Reliability Analysis Update

Transmission Expansion Advisory Committee
July 9, 2024

- 2024 Window 1 Updates
- 2023 Window 2 Projects 2nd Read
- 2022 Window 3 Scope Changes

Scope Changes: 502 Jct-Woodside-Aspen 500 kV & Doubs Corridor Projects

502 Jct – Woodside – Aspen 500 kV Project Scope Changes

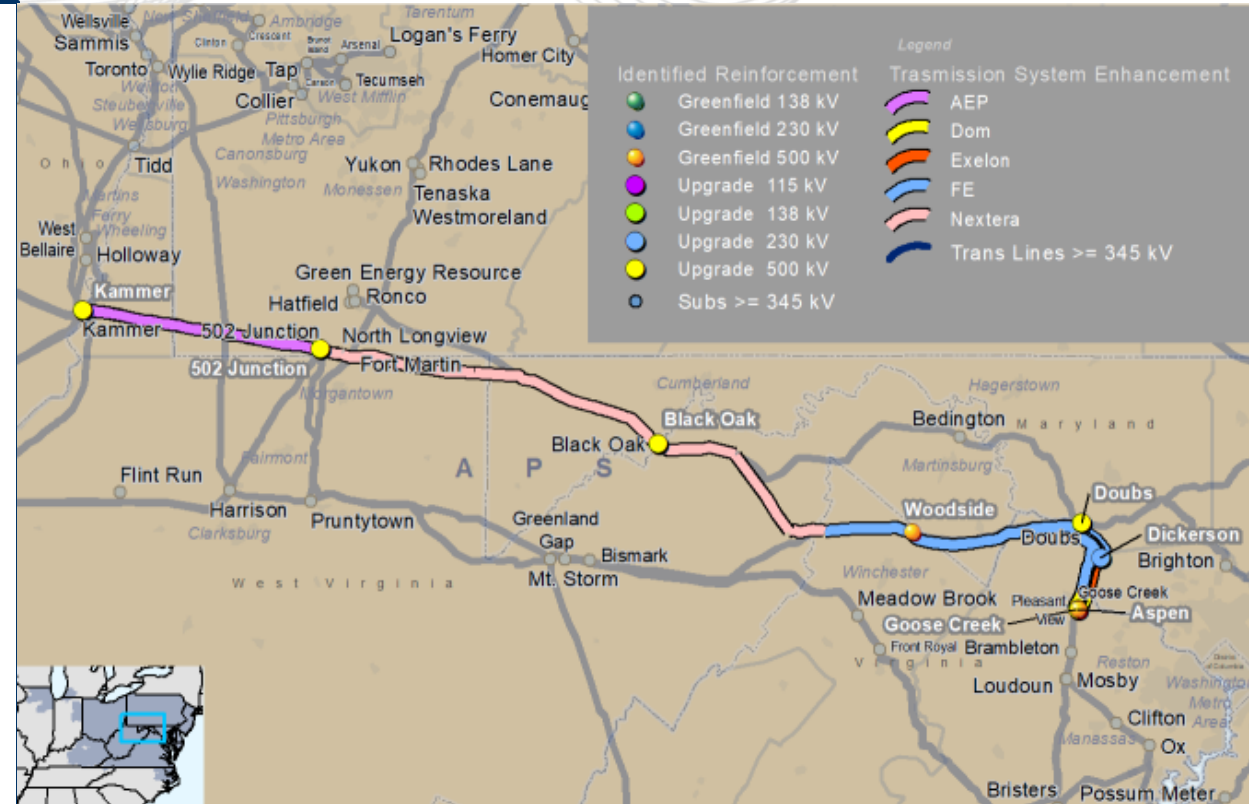
Rationale for Scope Changes:

The line section from Woodside to Aspen will be rerouted from the originally proposed greenfield line route to an alternate route within existing transmission line rights of way along the Doubs Corridor containing the rebuilt Doubs – Goose Creek and the new Doubs – Aspen 500 kV lines. This reroute is the outcome of successful collaboration between NextEra and the incumbent Transmission Owners to determine the most feasible route and minimize area impact for the new Woodside to Aspen 500 kV line segment.

As part of this change, the new 500 kV line from Woodside will now terminate into Goose Creek substation due to space constraints within the Corridor and also to minimize unnecessary line crossings.

- **Cancel b3800.119:** New 500 kV transmission line from Woodside substation to Aspen substation (in DOM zone) (NEET Portion) - \$71.72M

- **Scope Change for b3800.105:** Rebuild Millville-Doubs 138 kV for ~16 miles from structure MVF1-39 to structure MVF1-101 (outside of Doubs Substation) with 500 kV overbuild - \$147.45M
- **New Baseline Project b3800.128:** Construct 500 kV Line from existing structure MVF1-101 on the Doubs – Millville 138 kV Line, around Doubs Substation, and into the entrance of the Doubs – Goose Creek Corridor. (~2 miles) - \$13.20M
- **New Baseline Project b3800.129:** Construct new Woodside – Goose Creek 500 kV line for ~15 miles on single circuit monopole structures within the Doubs – Goose Creek Corridor. (FE Portion) - \$115.30M

Revised NextEra Total Cost: \$440.89M, Delta: -\$71.72M

Revised FE Total Cost: \$616.15, Delta: +\$223.60M

502 Jct – Woodside – Aspen 500 kV Project Scope Changes (cont.)

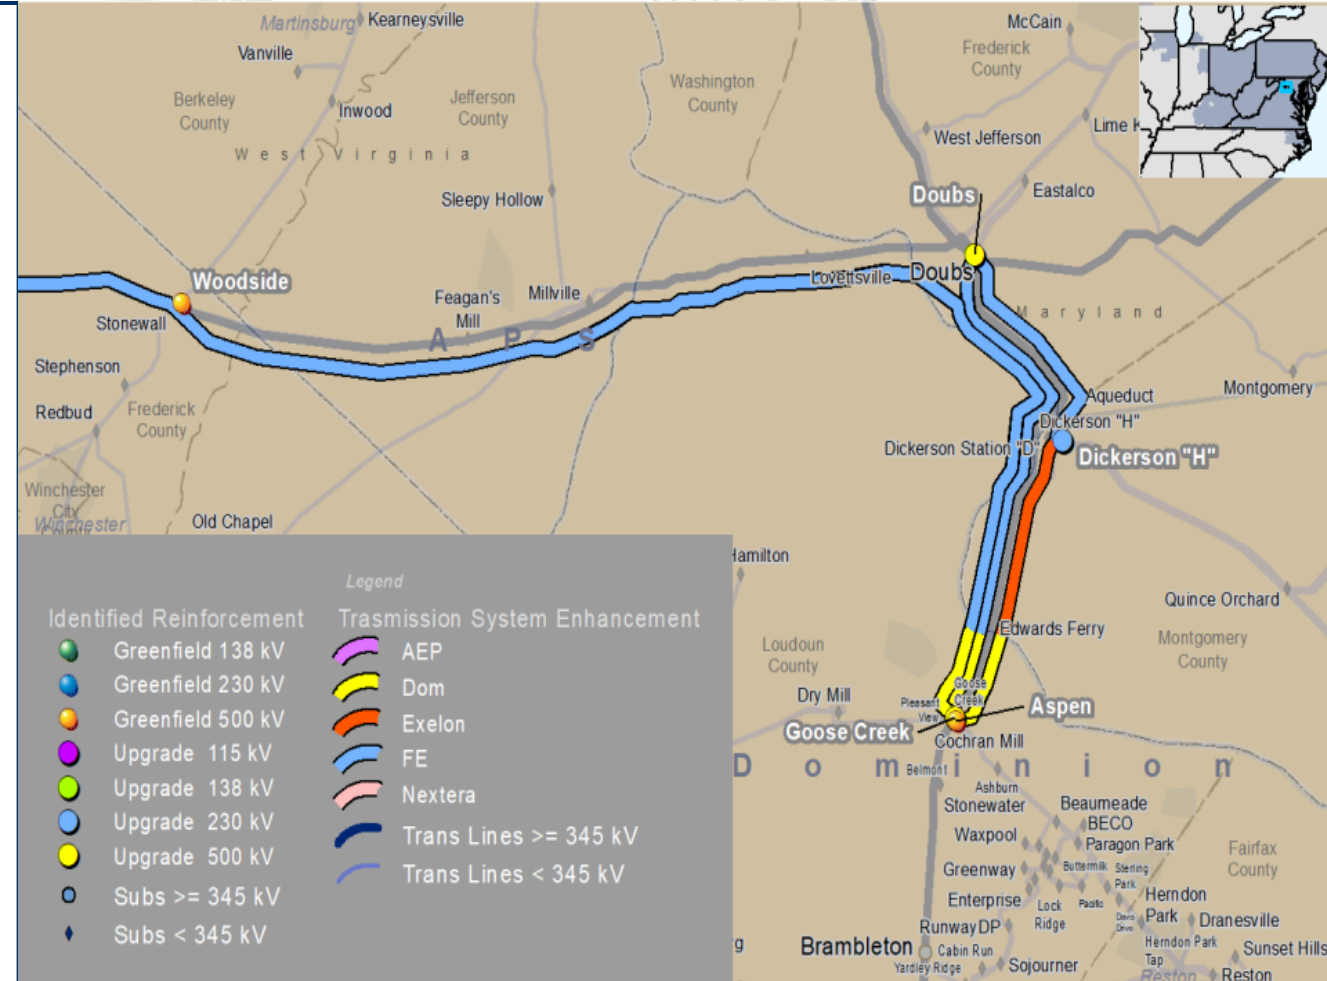
- **Scope Change for b3800.120:** Terminate new NextEra 500 kV line from Woodside into **Goose Creek substation. The Goose Creek 500kV cap bank will be moved to Aspen substation.** - \$30.49M (No Cost Change)
- **New Baseline Project b3800.375:** Construct new Woodside – Goose Creek 500 kV line for ~3 miles on single circuit monopole structures within the Doubs – Goose Creek Corridor. (DOM Portion) - \$15.60M
- **Revised DOM Total Cost: \$51.19, Delta: +\$15.60M**

Net Cost Change to 502 Jct – Woodside – Aspen Projects: +\$167.48M
